Re: **PETITION NO. 1612** – TRITEC Americas, LLC notice of election to waive exclusion from Connecticut Siting Council jurisdiction, pursuant to Connecticut General Statutes §16-50k(e), and petition for a declaratory ruling, pursuant to Connecticut General Statutes §4-176 and §16-50k, for the proposed construction, maintenance and operation of a 0.999-megawatt AC solar photovoltaic electric generating facility located at 37 Hunters Lane, Southington, Connecticut, and associated electrical interconnection. **Petitioner Response to Council Interrogatories.**

**Petition No. 1612
TRITEC Americas, LLC
37 Hunters Lane, Southington, Connecticut**

**Interrogatories
April 22, 2024**

Sheet Title:	Sheet #:
OVERALL SITE LAYOUT PLAN	2.10

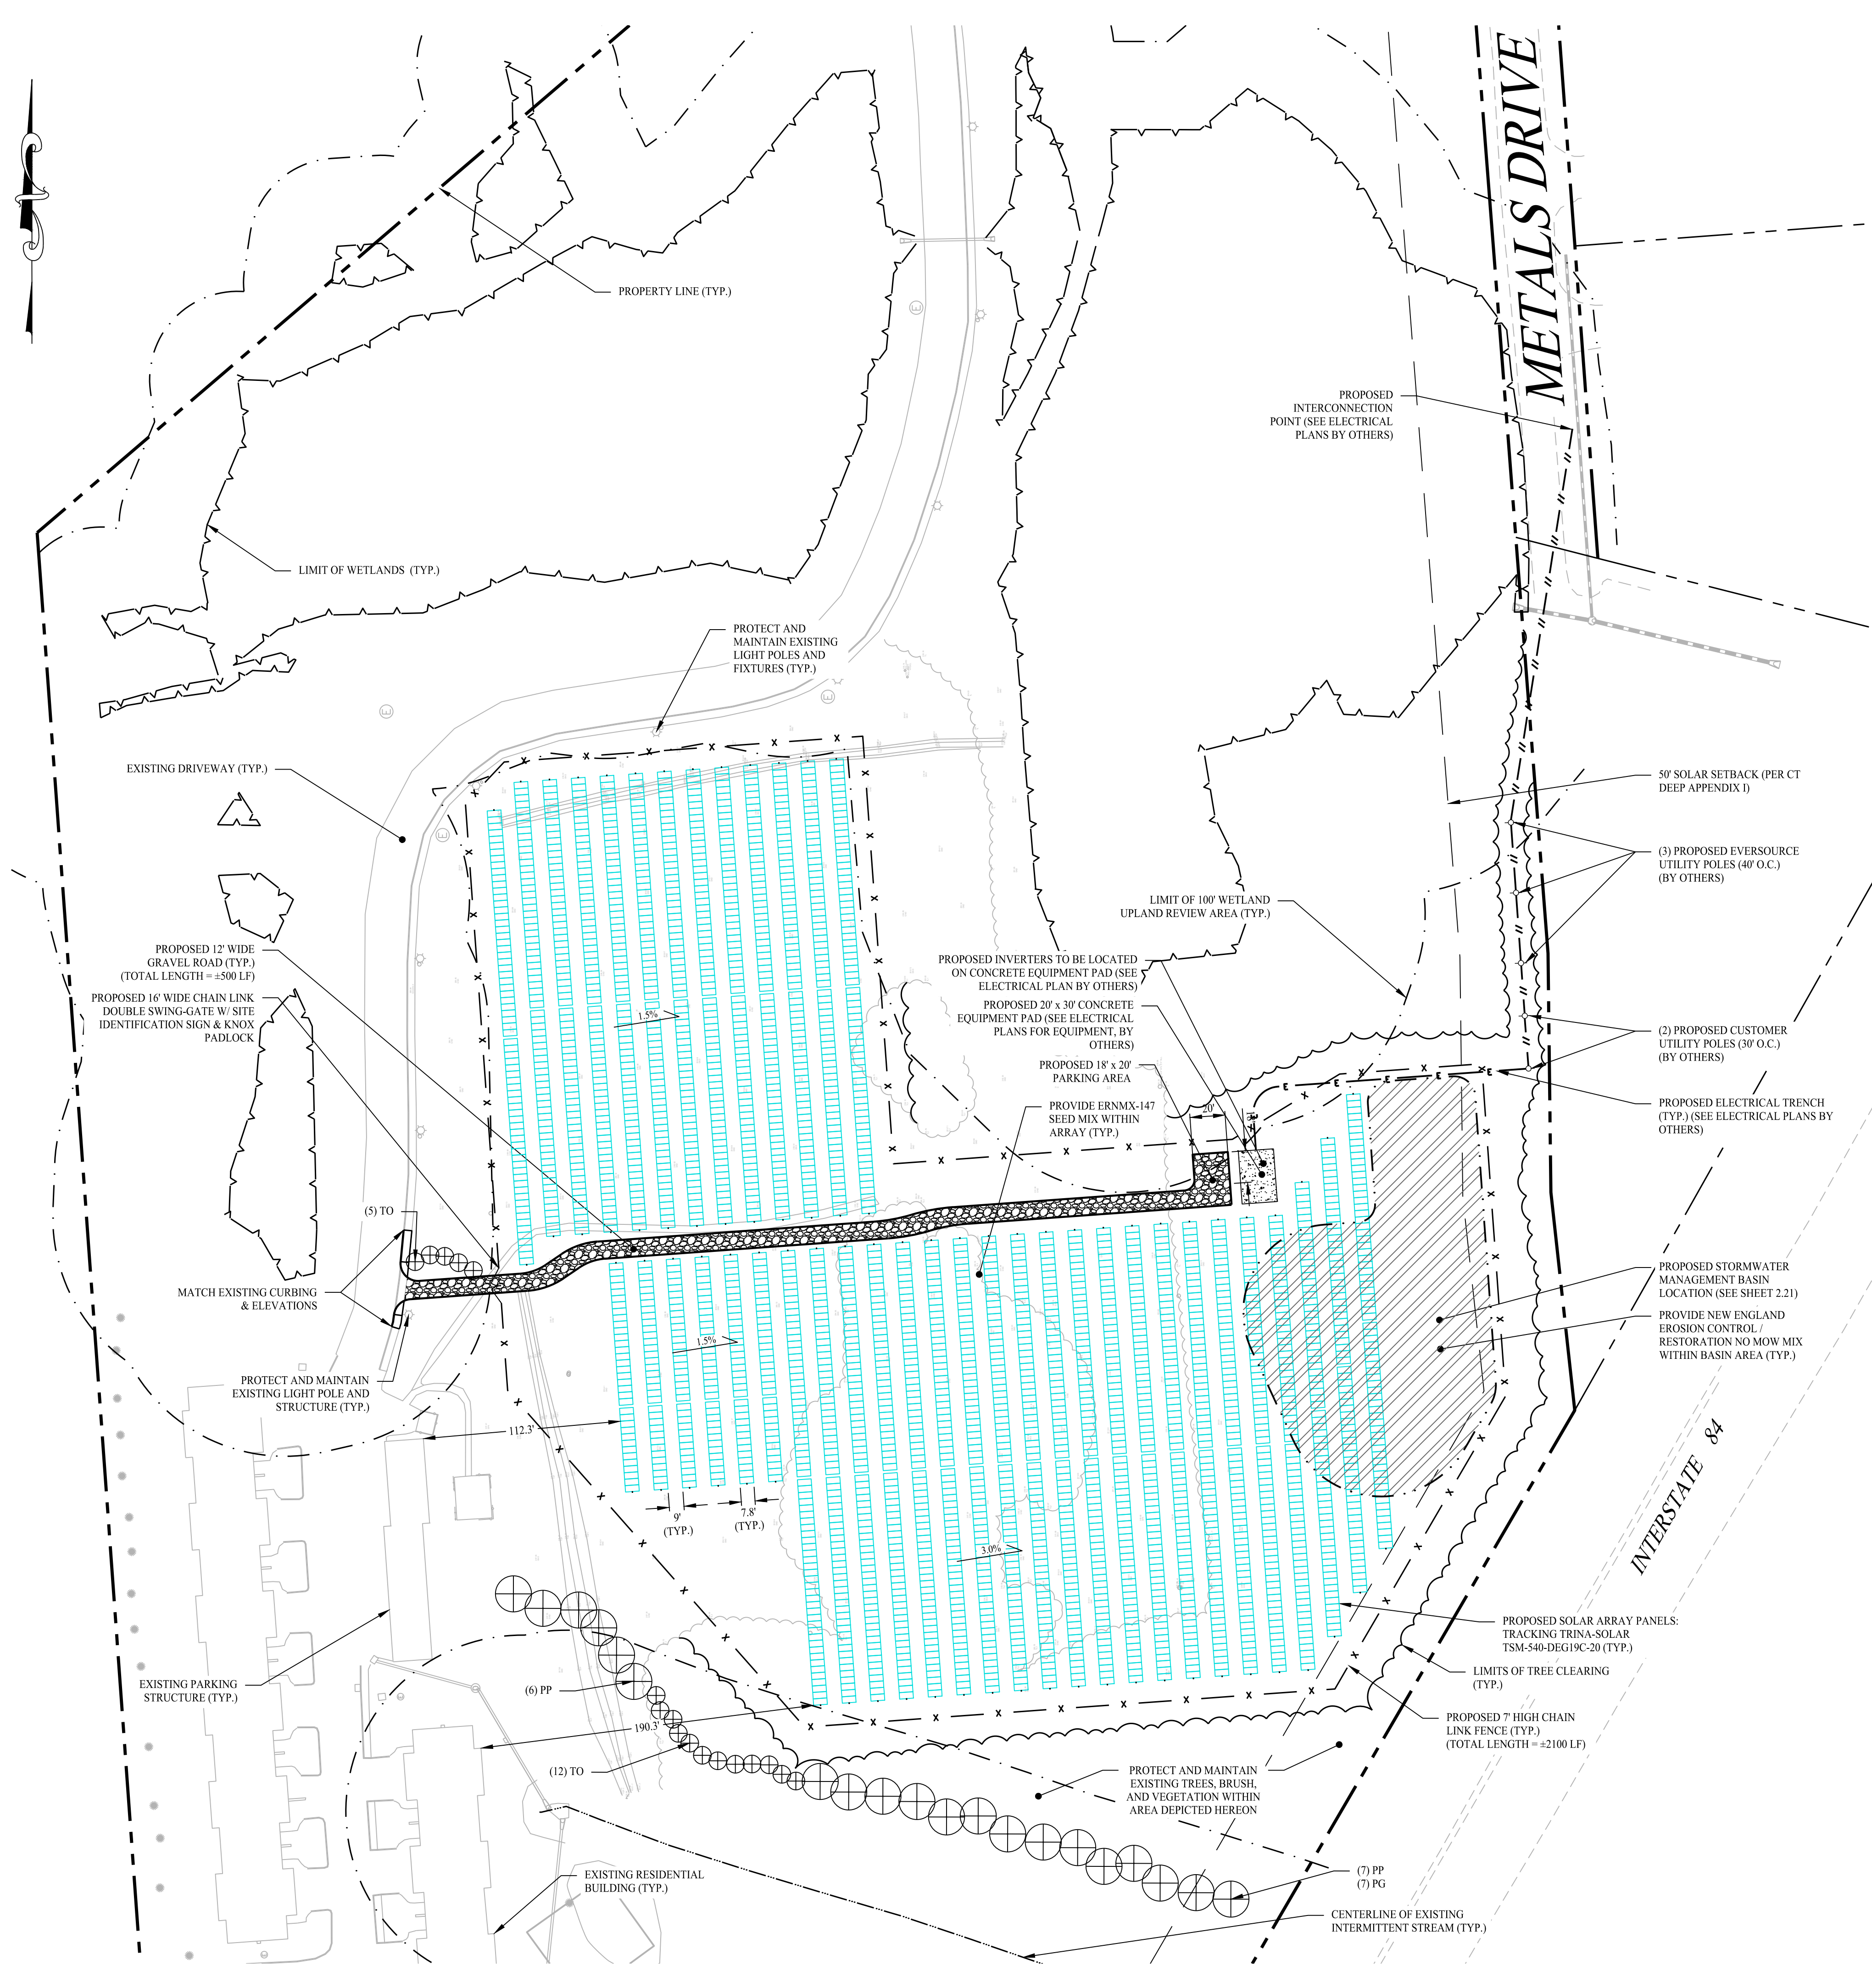
35. Provide the distance of the proposed gravel road entrance to the nearest residential structure.

36. Provide the distance of the nearest residential structure from the perimeter fence and the inverters at their closest points.

52. Referencing Petition Appendix B Site Plan 2.10 provide the distance of the proposed gravel access road from the wetland area to the west.

The Overall Site Layout Plan (Sheet 2.10) has been revised to show the distance to the nearest residential structure. Please see “Exhibit B: Revised Civil Plan Drawing Set.”

The Overall Site Layout Plan (Sheet 2.10) has been revised to show the distance to the nearest residential structure. Please see “Exhibit B: Revised Civil Plan Drawing Set.”

The Overall Site Layout Plan (Sheet 2.10) has been revised to show the distance to the wetlands. Please see “Exhibit B: Revised Civil Plan Drawing Set.”

Sheet Title:	SITE LAYOUT PLAN	Sheet #:	2.11
--------------	------------------	----------	------

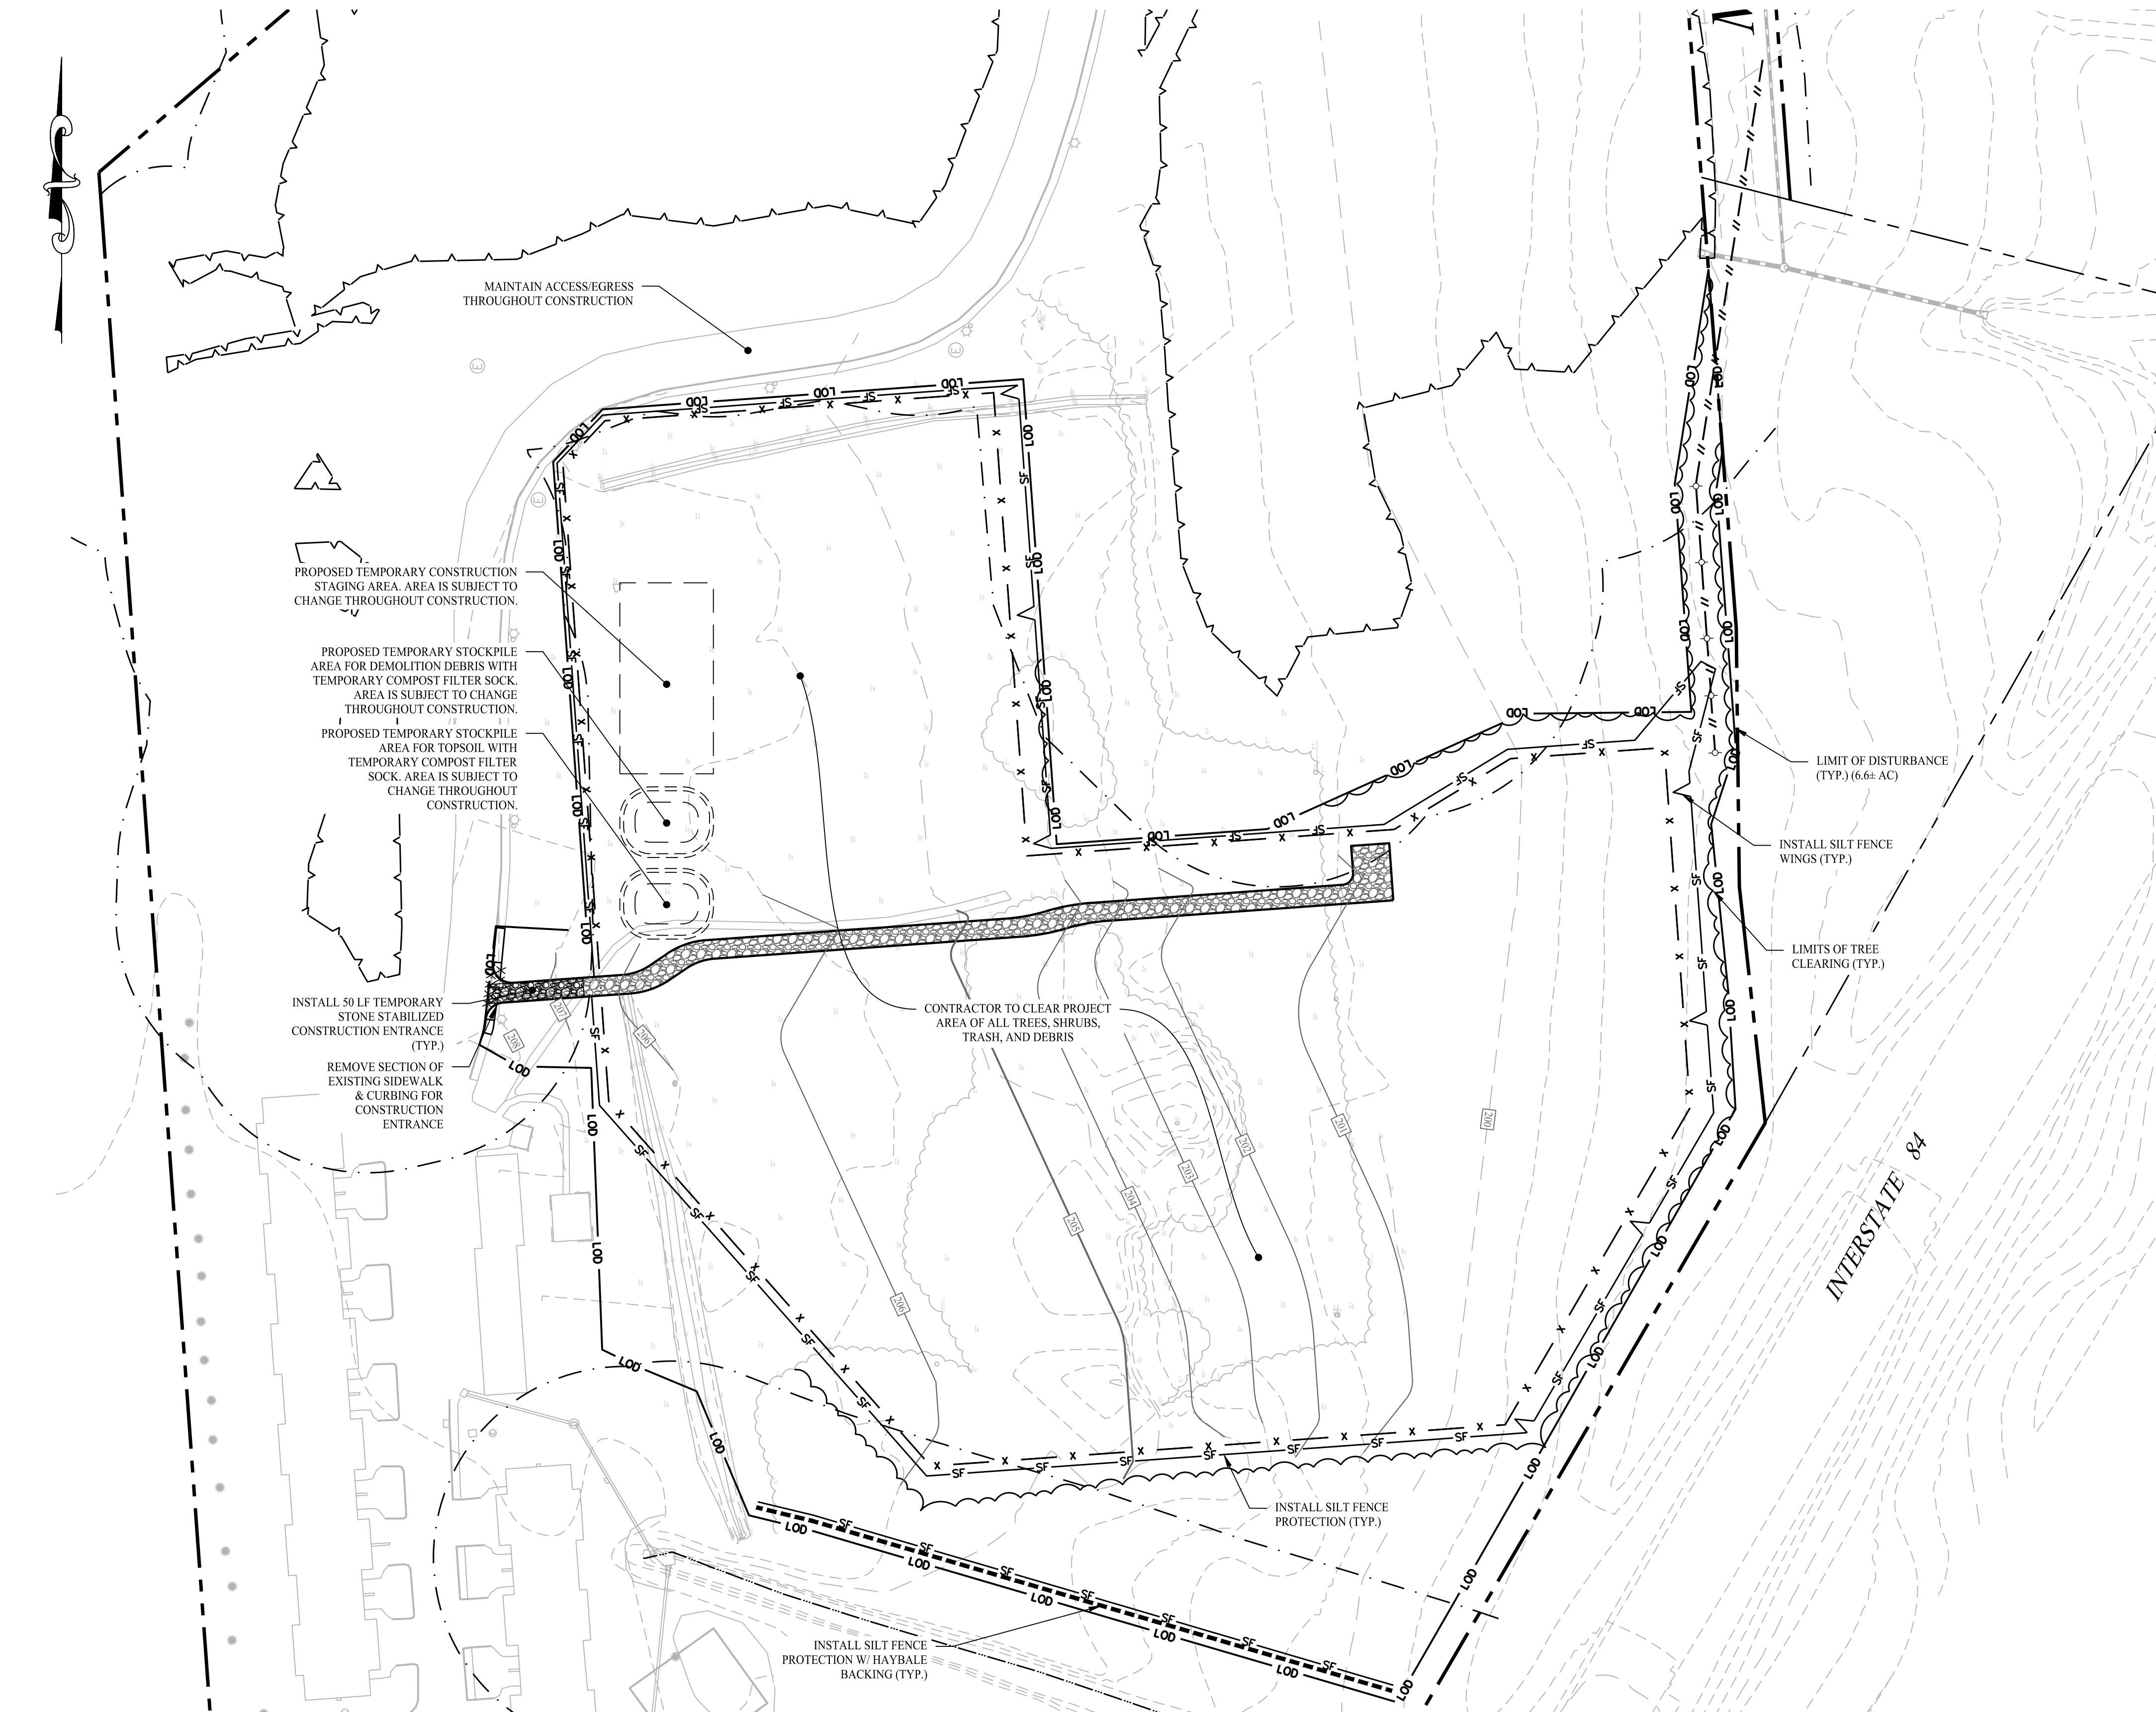
24. Referencing Petition Site Plan 2.11, are the inverters mounted on concrete pads or on posts?

32. Referencing Petition Appendix B, Site Plan 2.11, the underground electrical connection traverses a wetland area on the host parcel. Was an alternative electrical connection considered to avoid disturbance to the wetland? Explain.

Eversource is reviewing the interconnection requirements for the proposed Project and will ultimately dictate the location, quantity, and type of equipment needed. Petitioner is working with Eversource a potential alternate route for the interconnection to bypass the wetlands. This would require an easement from an abutting property. The revised Site Plan shows this alternate interconnection route with the result being no direct impacts to wetlands.
